PLANNING TECHNICAL REVIEW COMMITTEE –AGENDA

1. 10:30 AM – 11:00 AM: Amendment for Downtown Dover Storage, LLC, Assessor's Map 4, Lot 5, zoned CBD-G, located at 14 Broadway. (Proposal is to construct a 14,770 s.f. 4-story residential building with 38 units with revised covered parking and relocating internal staircase.) (WAIV-2024-0004) *[This item was previously heard by the Planning Technical Review Committee on March 28, 2024]*

PLAN SNAPSHOT REPORT WAIV-2024-0004 FOR CITY OF DOVER, N.H.

Re: Response to TRC Comments Letter
Proposed Residential Development at 14 Broadway

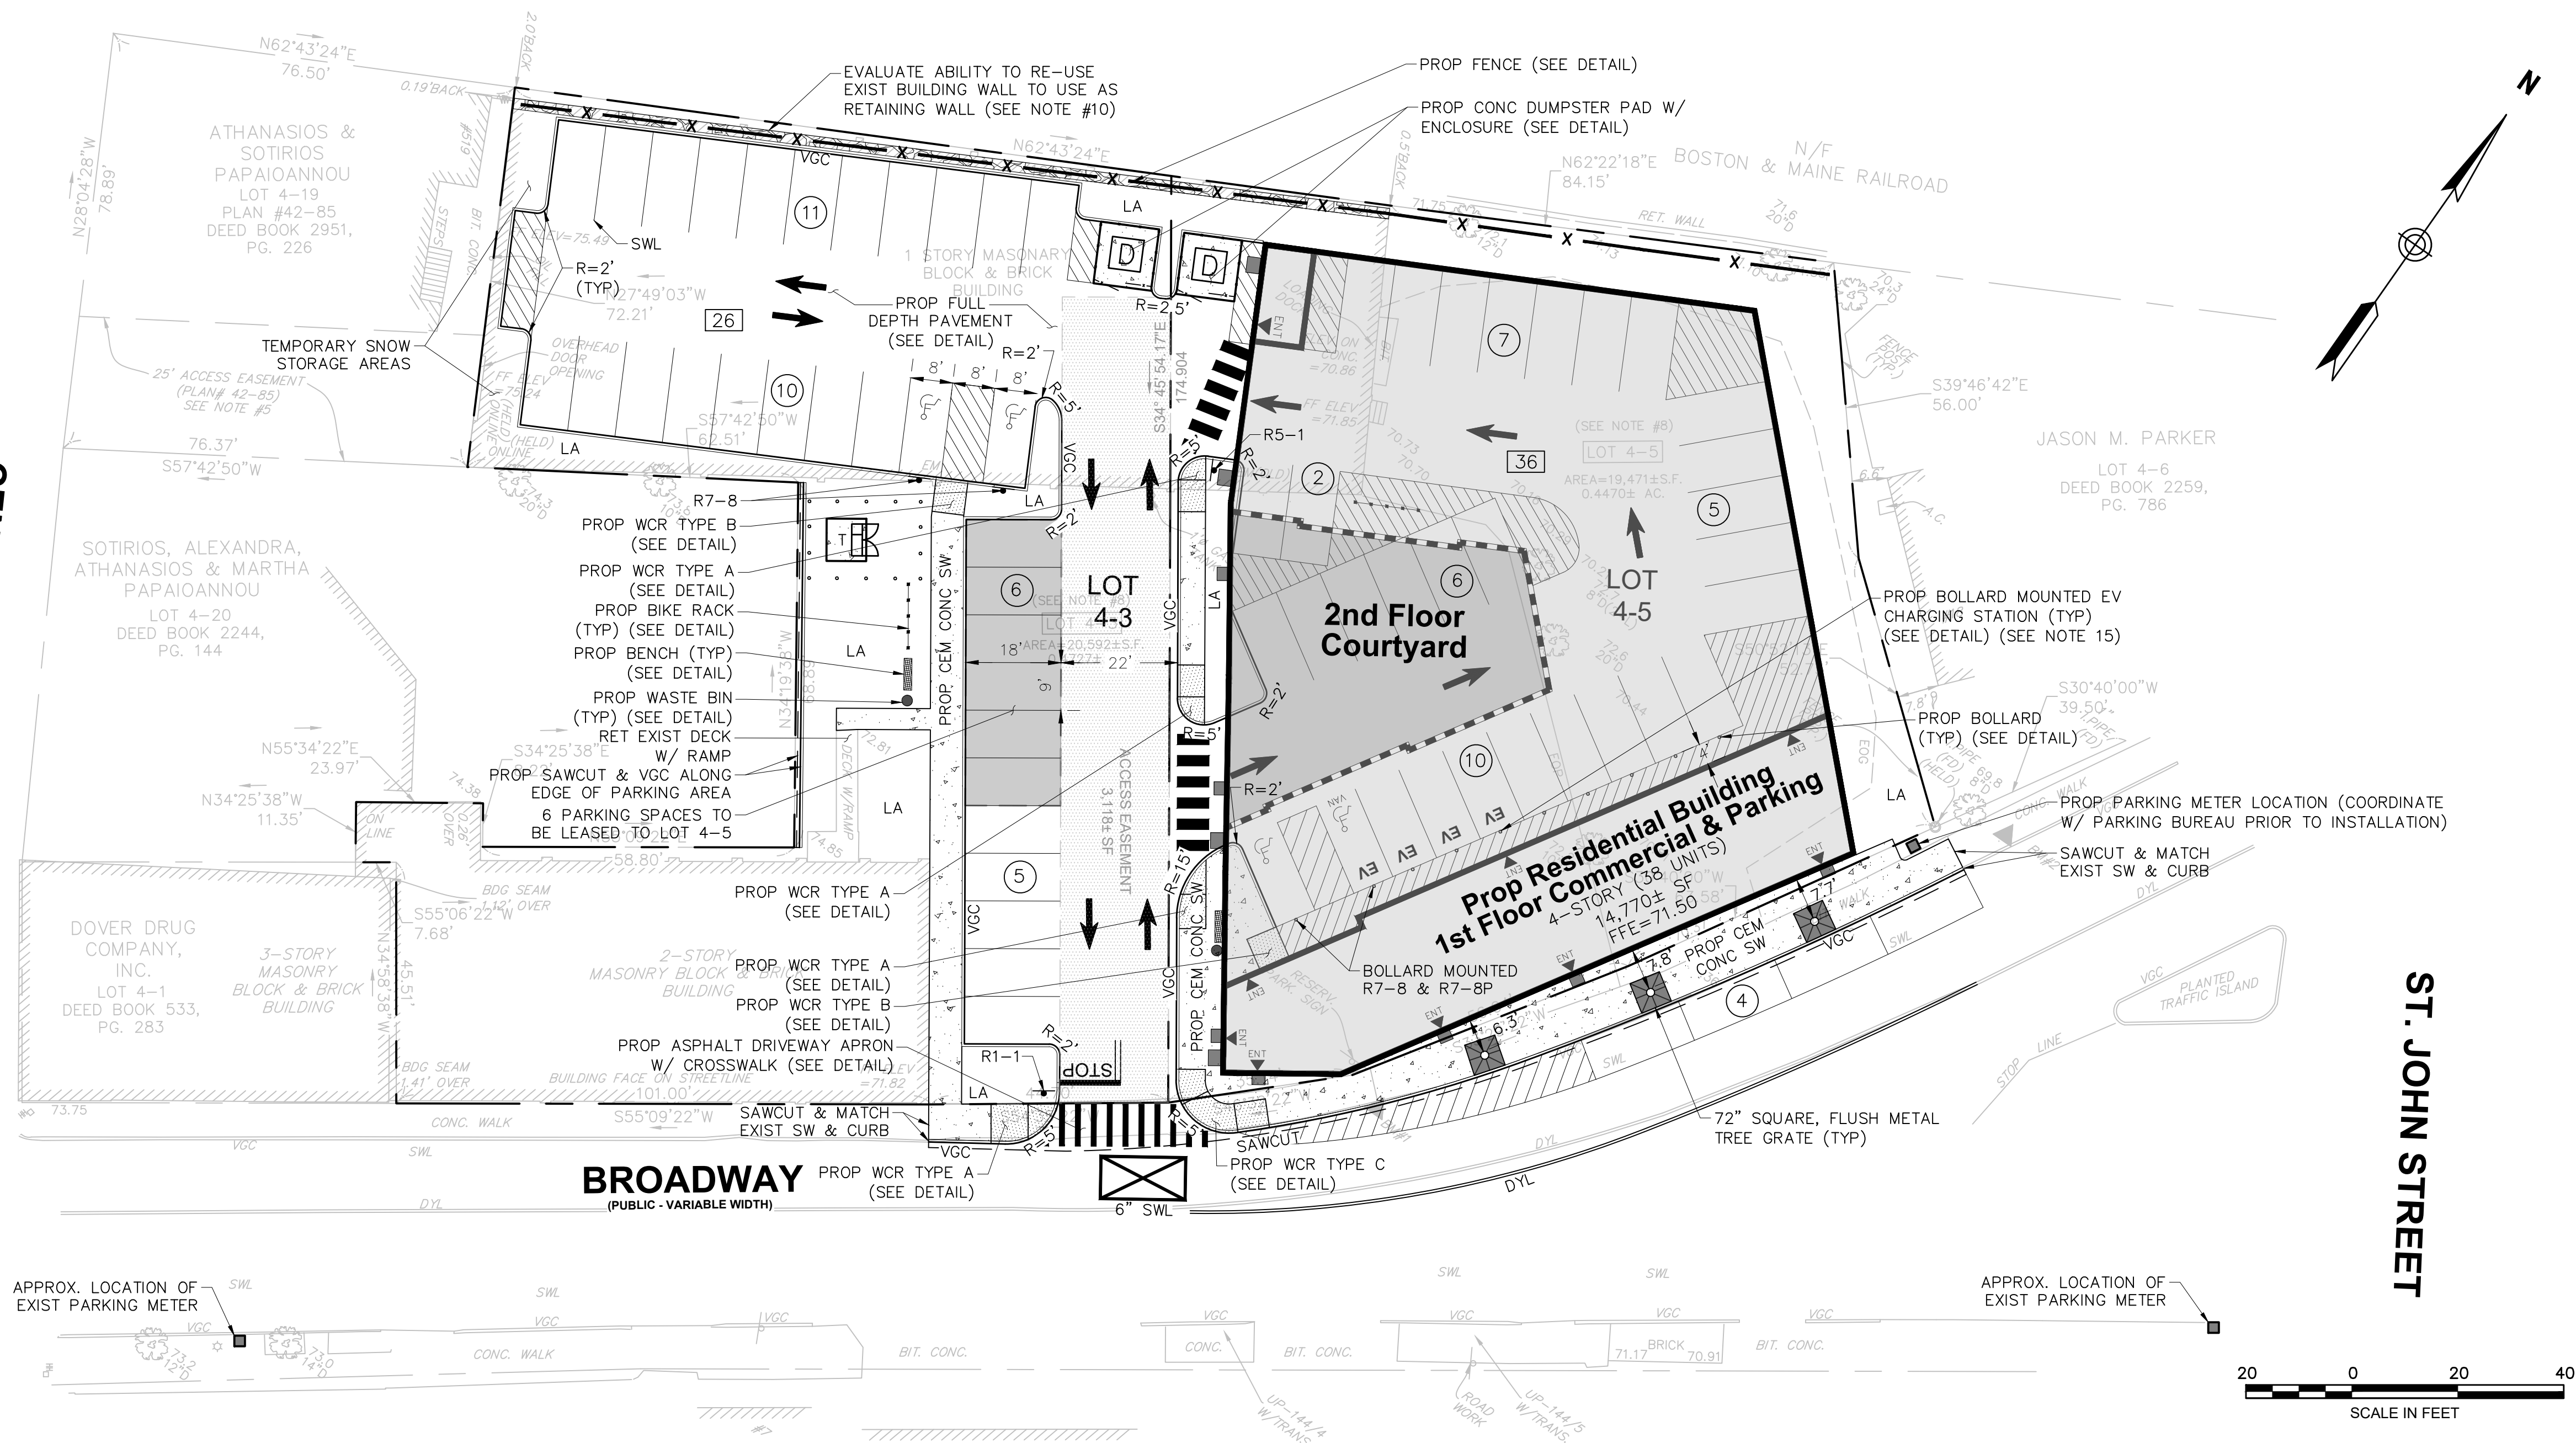
- Sheet C-4 shows removal of existing deck w/ ramp, but subsequent sheets show apparent addition of another deck/ramp, not labeled. Clarify if this is part of the scope of your proposed project.
- Traffic Impact Assessment, Page 3: elimination of some of all of the 4 proposed on-street spaces is discussed, but paragraph 3 does not articulate any clear recommendation. Revise paragraph 3 to draw a more specific conclusion.
- Coordinate with Parking Bureau for installation of a new multi space meter on north side of Broadway.
- Where would be appropriate commercial loading zone for your first floor units and abutting commercial property? Evaluate the Saint John/Broadway intersection for potential parking/loading zone improvements.

A note has been added to the Demolition Plan (Sheet C-4) that the contractor shall provide signs and barriers for sidewalk closure.

Layout &
Materials Plan

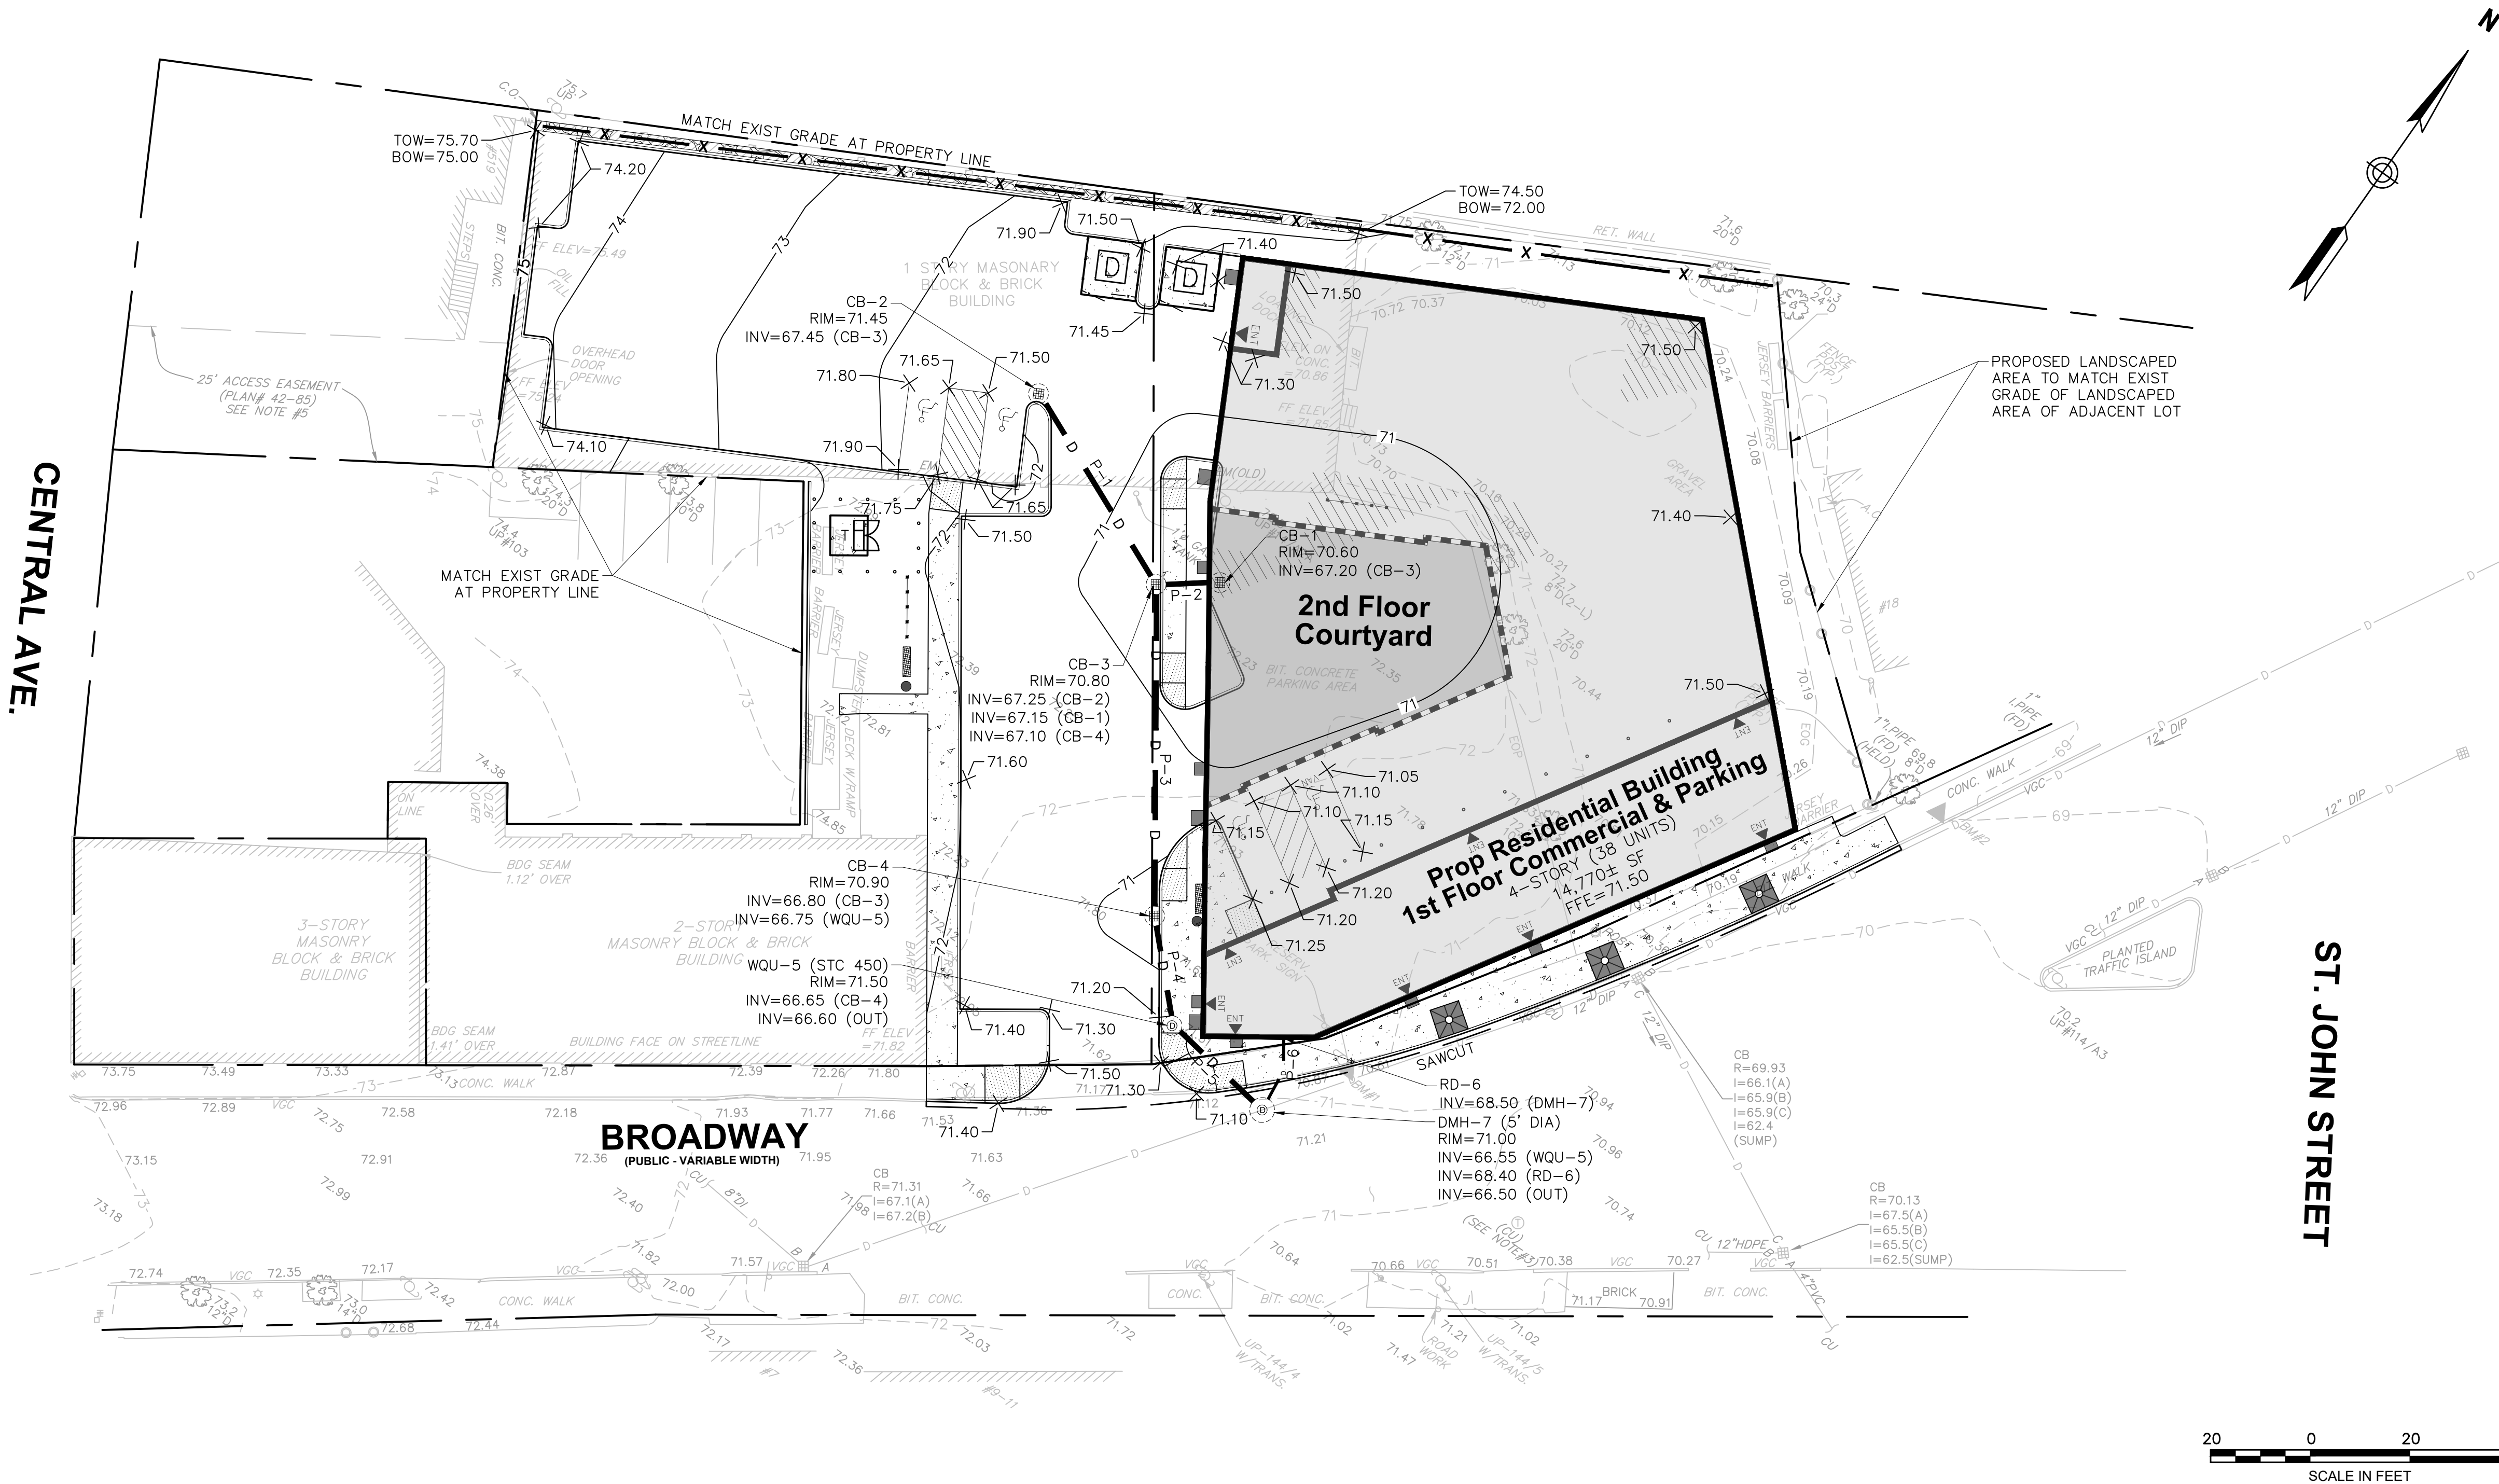
- Sheet C-5:

- Note is shown to evaluate use of existing wall as retaining structure. There is insufficient information on the plan about this wall to design a replacement wall. At a minimum the applicant should show the proposed top and bottom of wall and which side those are on. If a new wall is needed, is there enough room to install the wall? It appears to be on the property line with the B&MRR. **Recommend that that evaluation be conducted and sealed by a professional engineer and provided to Community Services as a condition of approval prior to the issuance of a CO.**

- Remove the existing conditions layer from Sheet C-5 and other subsequent sheets, where jersey barriers, pavement markings, etc. to be removed. Some labels are replicated on multiple sheets.
- Contractor will be required to provide signs and barriers for sidewalk closure, if applicable.
- Sheet C-10 and related notes for cap and reuse of building wall does not show and dimensions of the wall. Provide more detail or clarify as necessary.
- Except as appears to be shown on landscaping Sheet L-1, the plan set is confusing on the proposed layout of the space between Lots 4-20 and 4-3 (where the jersey barriers are to be removed). Potential concern with lack of protections from vehicles on Lot 4-20.
- Sheet PB-08, View from Broadway Looking North: is red façade color intended to match adjacent property? Consider toning down the bright red.

- **Note is shown to evaluate use of existing wall as retaining structure. There is insufficient information on the plan about this wall to design a replacement wall. At a minimum the applicant should show the proposed top and bottom of wall and which side those are on. If a new wall is needed, is there enough room to install the wall? It appears to be on the property line with the B&MRR. Recommend that that evaluation be conducted and sealed by a professional engineer and provided to Community Services as a condition of approval prior to the issuance of a CO.**
The proposed top and bottom elevations of the retaining wall have been added to the Grading & Drainage Plan (Sheet C-6). A note has been added to the Layout & Materials Plan (Sheet C-5) which states that an evaluation of the existing wall shall be conducted and sealed by a professional engineer prior to issuance of a CO. If the existing wall is determined to be structurally insufficient, there is enough room to construct a new segmental block retaining wall.

The existing conditions layers which show jersey barriers, pavement markings, etc. have been removed from the Layout & Materials Plan (Sheet C-5).

The area between lot 4-20 and 4-3 will be utilized as a landscaped area which contains a park bench, bike rack, waste bin, deck with a ramp, and electrical transformer. The transformer is surrounded by bollards which will provide protection from vehicles on both lots. Additionally, vertical granite curb will be installed along the edge of the parking area for to delineate and deter vehicles from encroaching on the landscaped area as shown in the Layout & Materials Plan (Sheet C-5).

The project scope has been revised to retain the existing deck with ramp and add a sidewalk leading to the ramp as shown in the Layout & Materials Plan (Sheet C-5).
